Project: **NYC Police Memorial Vault
Conditioning And Storm
Protection Design Project**

RE: **Addendum #2**
of Pages: **13**

ATTACHMENT #1A
PLUMBING PLAN DRAWING P.1
FROM POLICE MEMORIAL'S
ORIGINAL DESIGN DRAWINGS

ATTACHMENT #1C
**RENDERED MAP OF POLICE MEMORIAL
PROJECT SITE AND SURROUNDINGS**

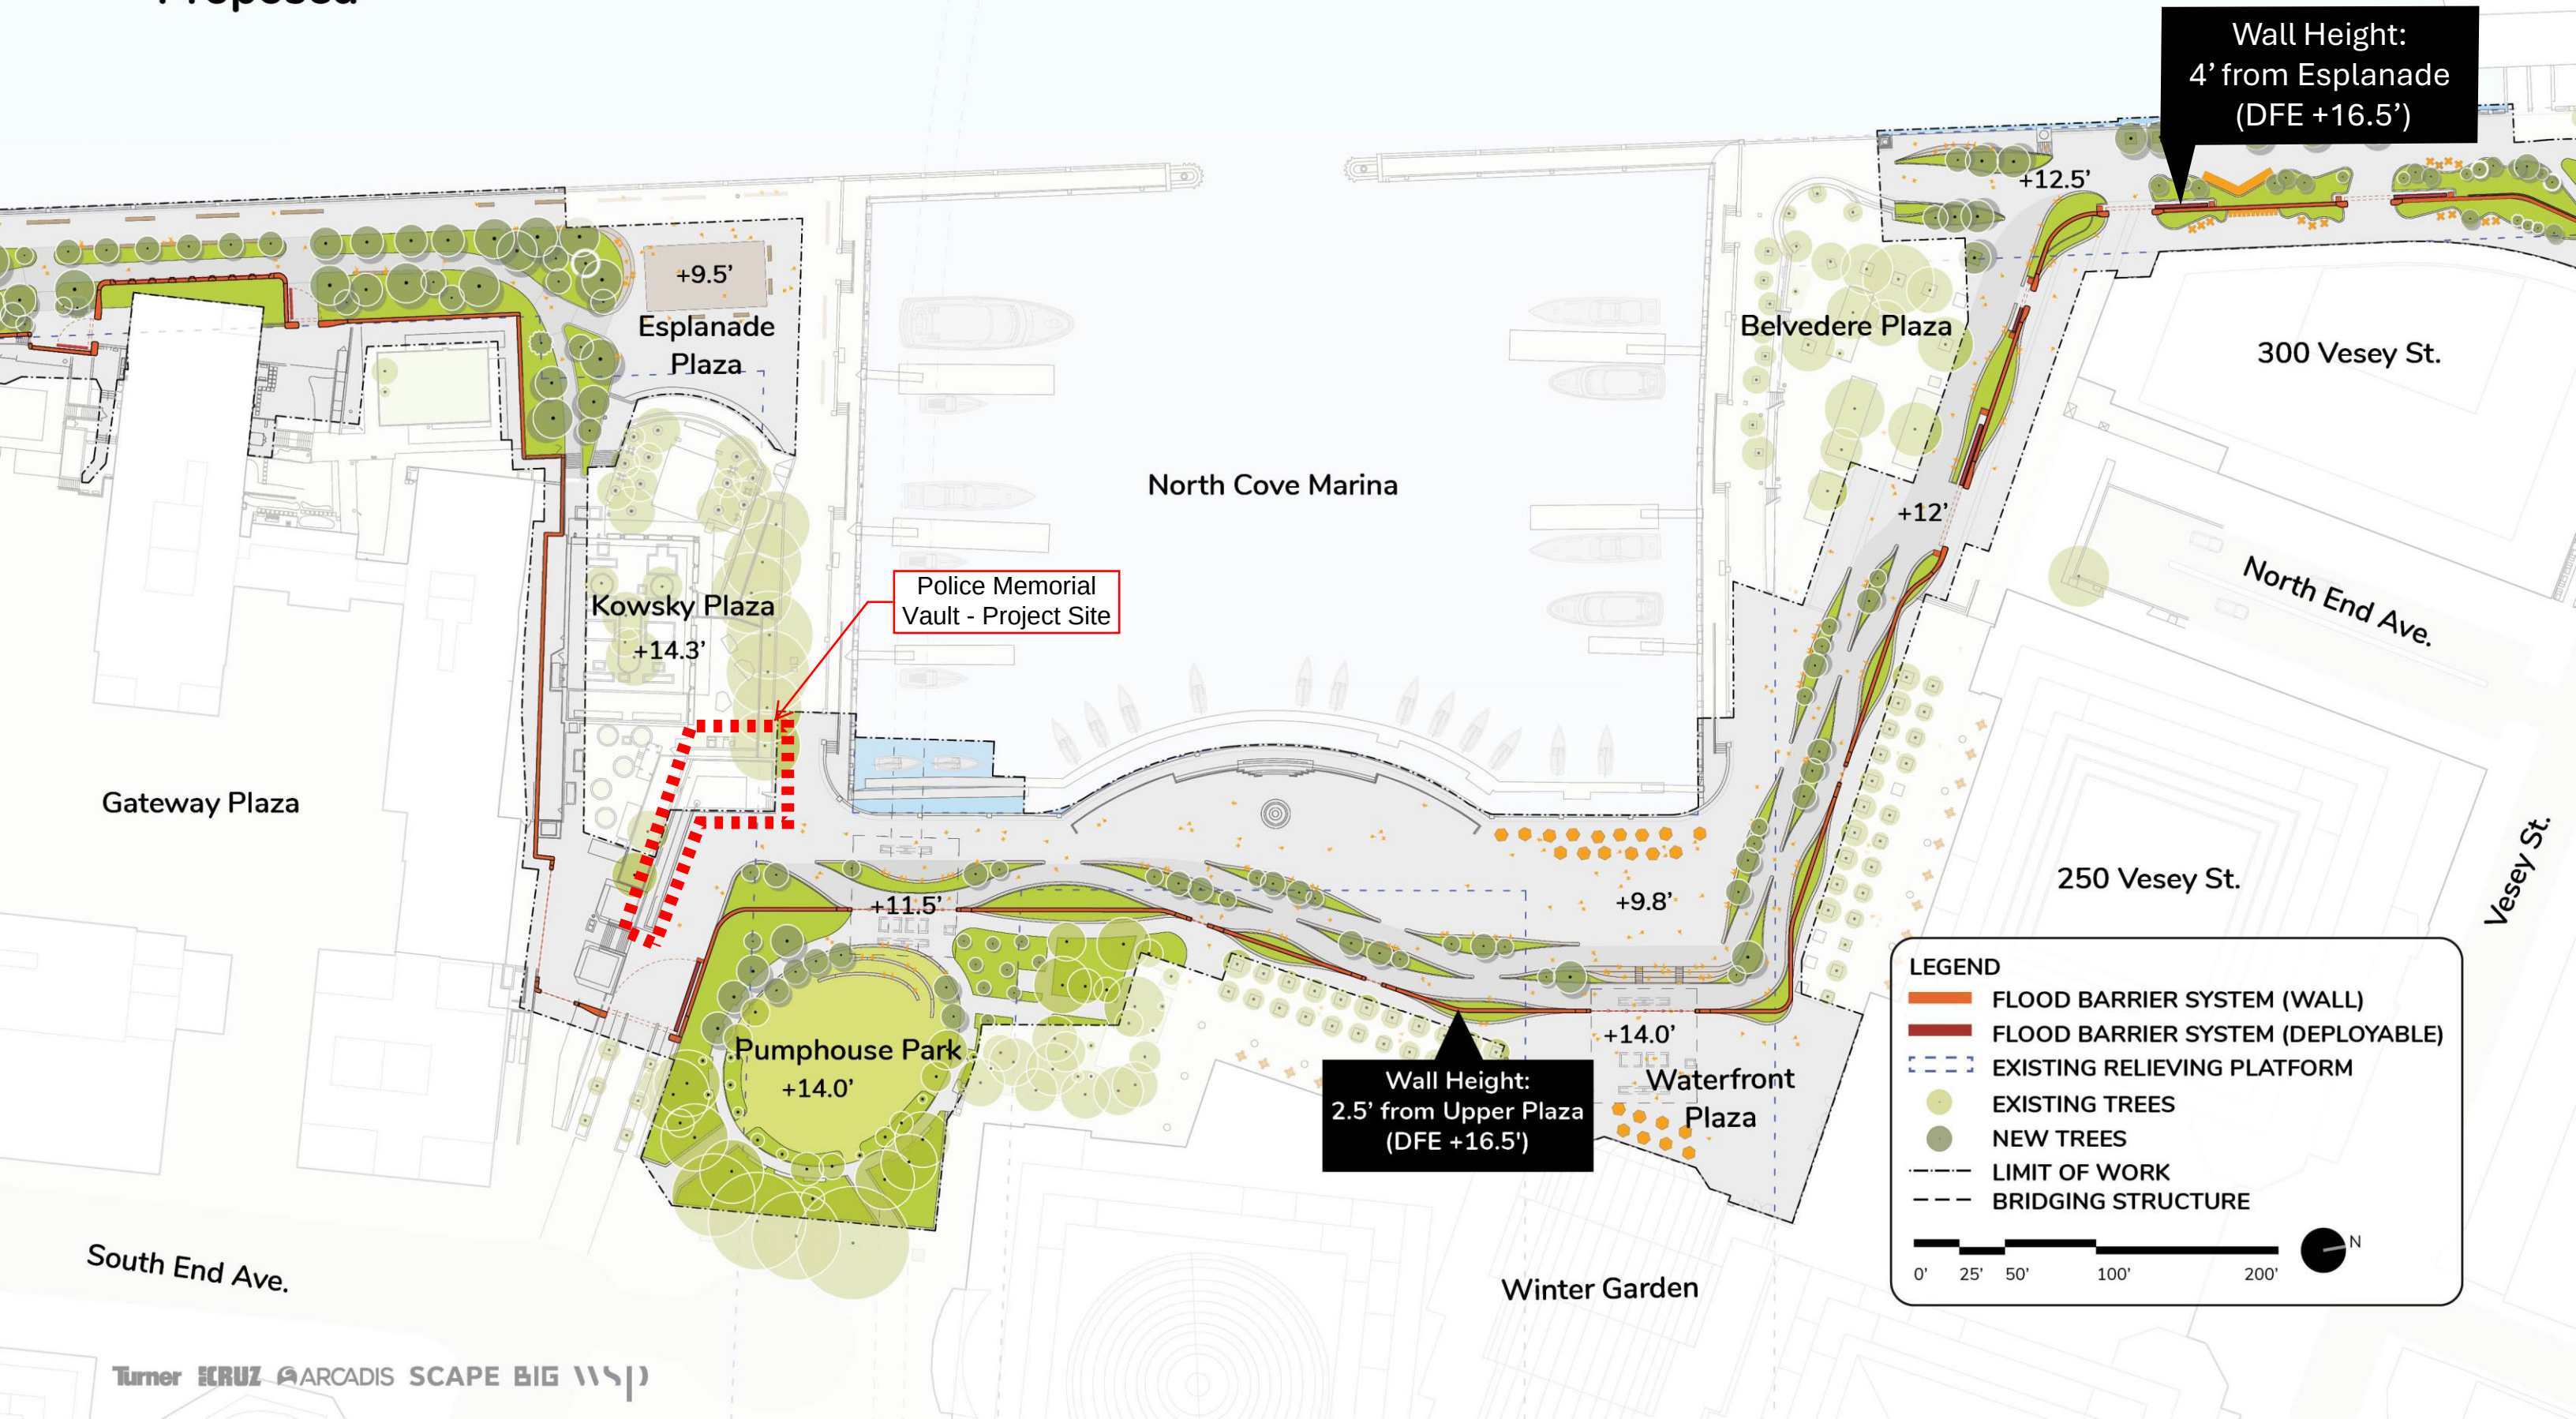
2. Please indicate what is the Design Flood Elevation that the existing resiliency project is designing to. Is there a survey denoting the existing grade elevation of the memorial and the dog run? ***Included in Attachment #1C of this addendum is a rendered map showing the grade elevation of the Project Site and surrounding area.***
